**City of Bellevue
Development Services Department
Land Use Staff Report**

Proposal Name: Lower Coal Creek Flood Hazard Reduction Project

File Number: 16-145319-LO

The purpose of this memorandum is to document updated responses to the Habitat Log Typical Detail for the Lower Coal Creek Culvert Replacement Project from the Muckleshoot Tribe sent to Parametrix on January 13, 2017 in an email from Karen Walter.

(2) TYPICAL HABITAT LOG CONNECTION DETAIL
N.T.S.

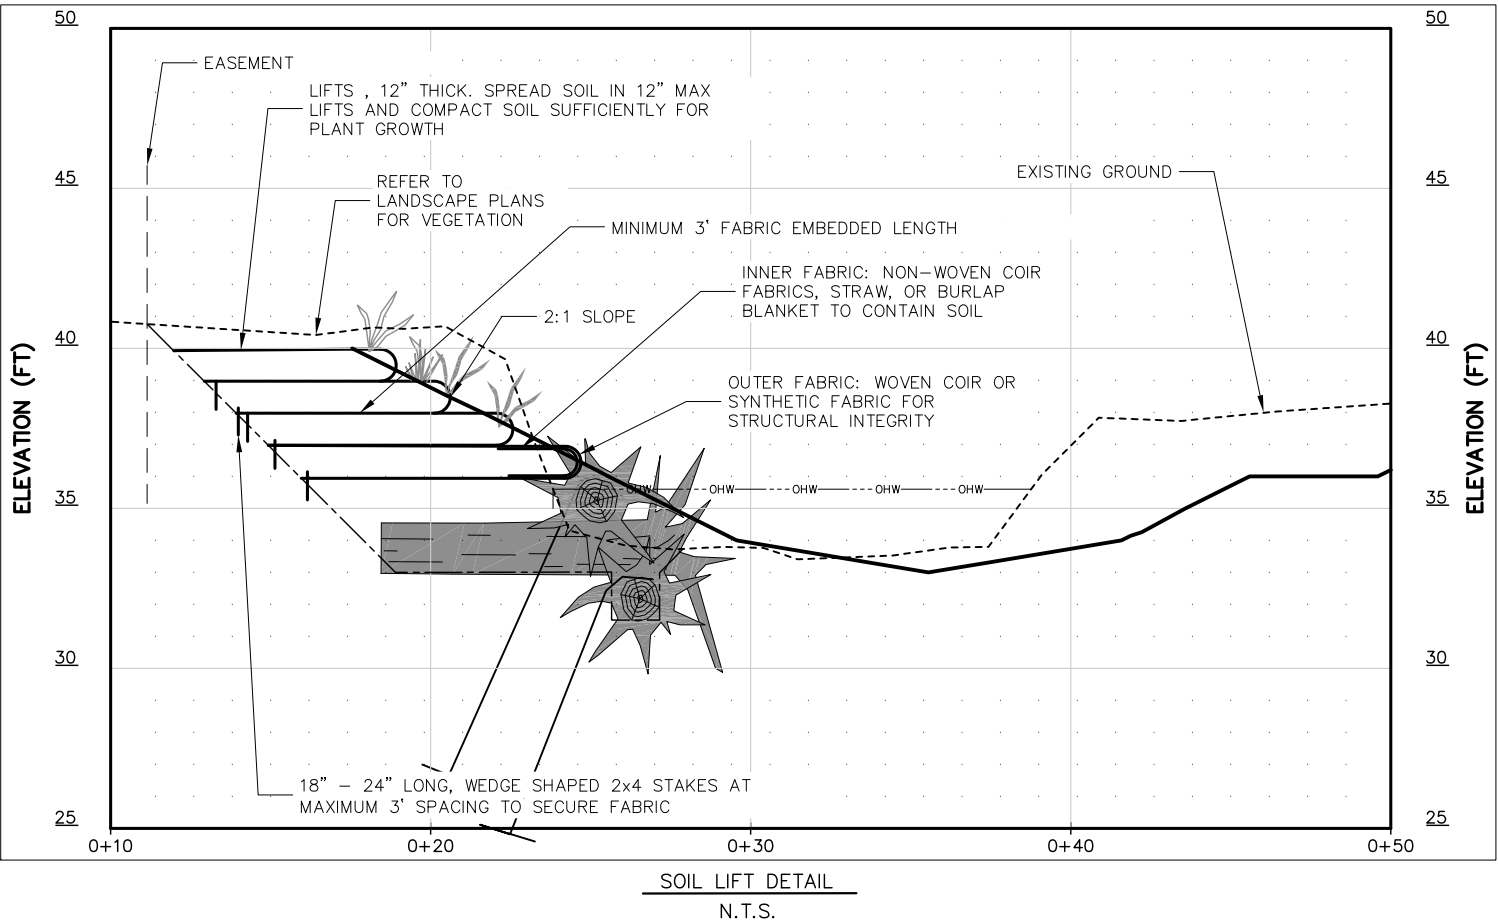
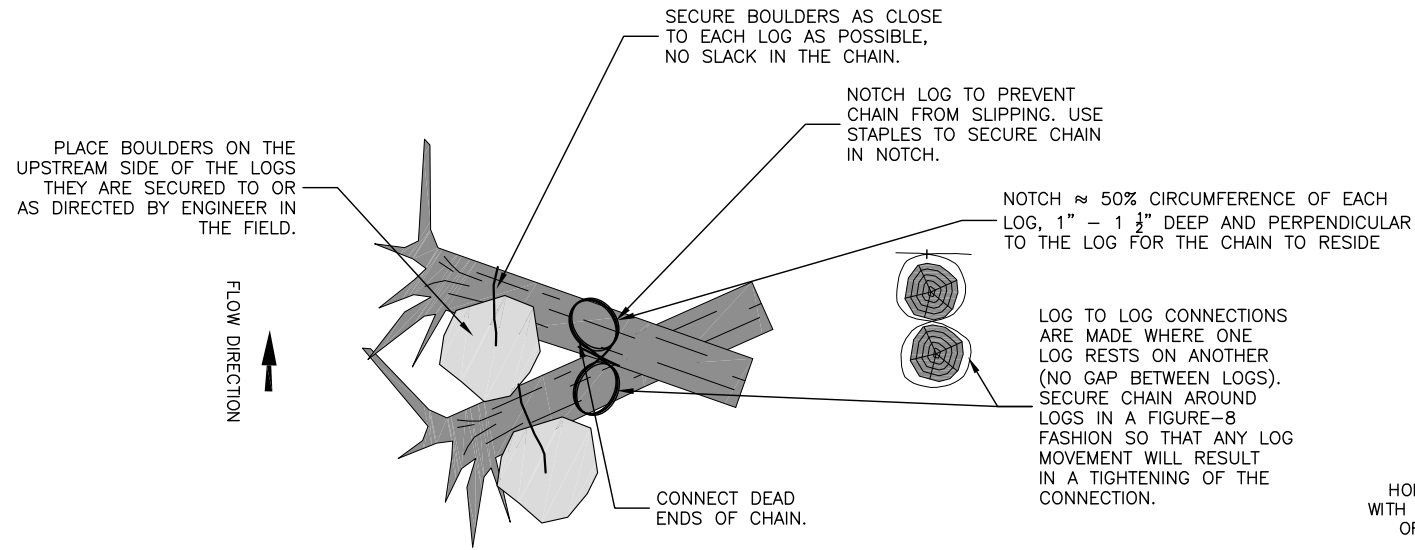
The proposed 2 x 1-ton boulders shown in the wood design (sheet 7 of 30% drawings) is a concern, too, as these boulders will harden the bank and reduce scour in the margins that create habitat; reduce access to interstitial spaces for juvenile salmon and are considerably larger than what is found in the natural stream bed substrate currently (see Figure 15; D90 surface sediment is approximately 115 mm or 4.72 inches). In summary, these designs are not very fish friendly. Wood should be used as the dominate feature within the wetted width for bank stabilization and habitat mitigation, not the proposed oversized rock.

The number of wood pieces included as mitigation for this project was based on the number of trees to be removed during construction.

Riparian conditions in the referenced upstream reach of Coal Creek are very different than conditions in the project reach in lower Coal Creek where residential properties abut the channel and City ownership is limited to the

existing road rights of way. In respect to the upstream reach referenced in the comment, that reach of Coal Creek flows through a natural greenbelt area that is entirely owned by the City.

The design reflects the existing land use and associated risk factors that occur in the project area, which is very different than the conditions that occur upstream. The wood design is based on reach-specific hydraulic and hydrologic modeling and the associate forces the installed wood are expected to encounter. The proposed boulders are provided to anchor the structures and will be buried in the structures, streambanks and channel. These sites also have extremely poor subsurface conditions, which will preclude the use of mechanical anchors. Also, the right of way and drainage easement are narrow with limited space for installation of wood structures. As a result, wood structures need to be relatively compact.

Wood Detail Comment

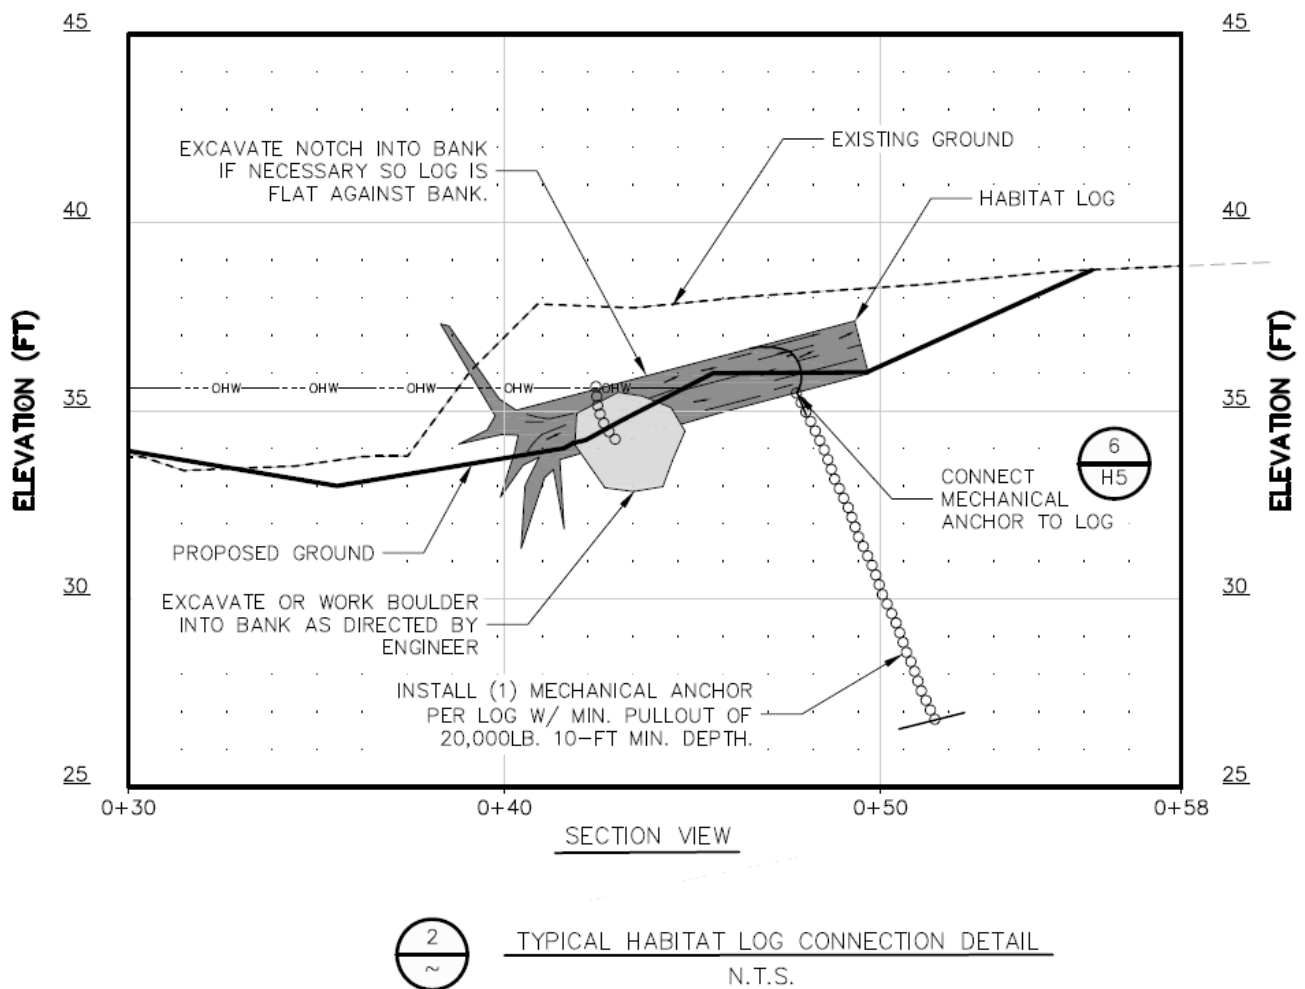
With respect to the wood design, the revised habitat log detail shows a very limited amount of the mitigation wood within the ordinary high water mark. The mitigation wood (41 pieces proposed) should be placed such that a minimum of 1/3 of the log length. The rock that is used for ballast and stability should be set back into the bank and not exposed to flows. Both of these design changes are needed to maximize habitat benefits to salmon (particularly juveniles) and to minimize the creation of salmon predator habitat. The wood design is an important component because as noted in our comments and the responses, it is unlikely that wood will come from upstream sources in a large part due to the trash rack on the I-405 culvert upstream which collects wood that would otherwise transport to this portion of Coal Creek. This wood is typically not relocated downstream to our knowledge.
